VILLAGE OF HOMEWOOD

MEMORANDUM

Topic: Case 24-26, Ollie’s/Brunswick Zone Redevelopment – 3043-3055 W 183rd Street

Figure 1: Subject site context. Grey areas indicate additional commercial outlots to be reviewed by Appearance Commission at future meetings.

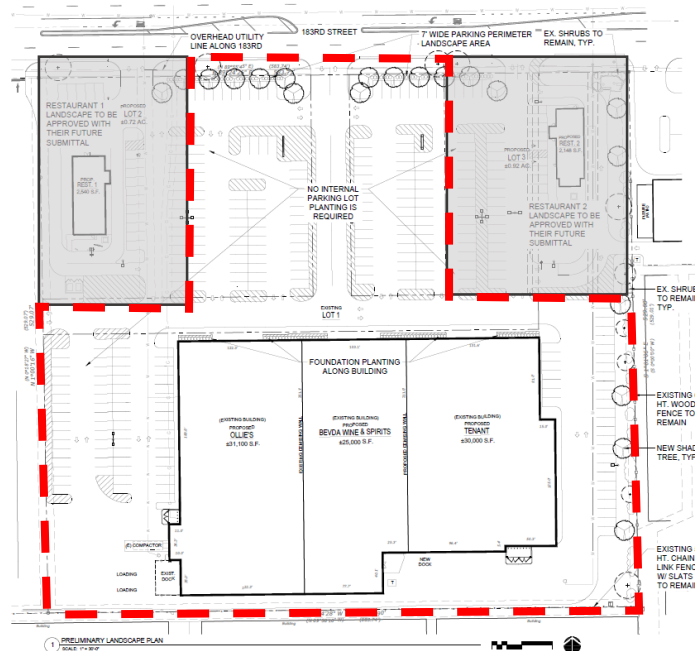
The subject site is located within the proposed 183rd West Tax Increment Financing District. As a part of this redevelopment effort, two additional outlots were created when the resubdivision of the subject site was approved on April 23, 2024 by the Village Board of Trustees. These outlots are identified in grey on Figure 1 and are *not* subject to this Appearance Review. Each of the two outlots will be reviewed separately by the Appearance Commission at a later undetermined date.
